John Stacey

Whiteheads Farm, Cressing Road, Witham, Essex, CM8 1RL

Further Submission dated 21/07/2026

Looking at NG Responses in REP6-114 to my representation REP5-301

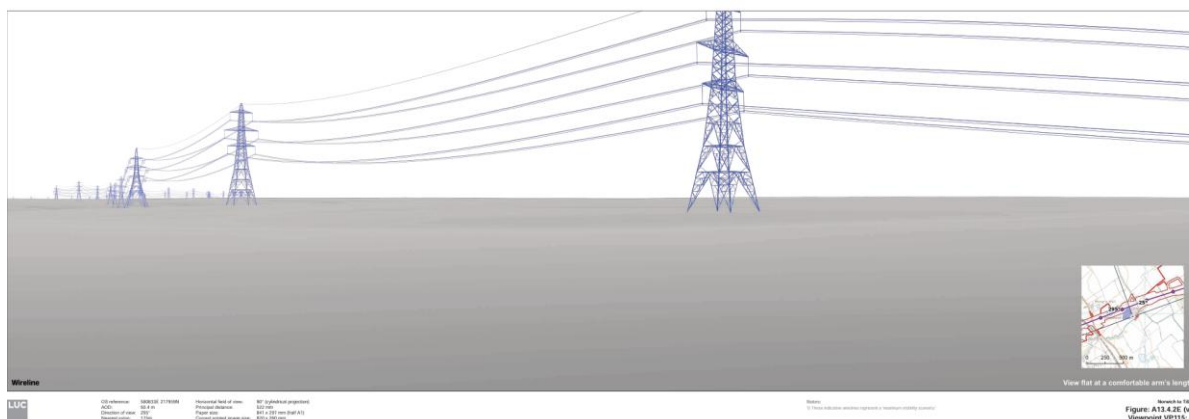
As pointed out this is significantly less than Eire Grid are offering.

Could NG show their workings to support their claim that it is competitive.

In terms of not being able to farm between a pylon and a field boundary will this be part of the injurious compensation claim and how will this be calculated ?

Additionally the restrictions that are imposed due the pylon being there along with the 30m restriction around the pylon, as well as the oversailing. Where are they accounted for ?

A figure of only £8,000 surely cannot account for all of this, will this be another injurious compensation claim as all of this is cannot be included in this figure as its not sufficient?

National Grid is confident that the payments set out in its Land Rights Strategy and Payments Schedule for Assets are extremely competitive in comparison to the likely compensation that may be awarded on a statutory land compensation basis.
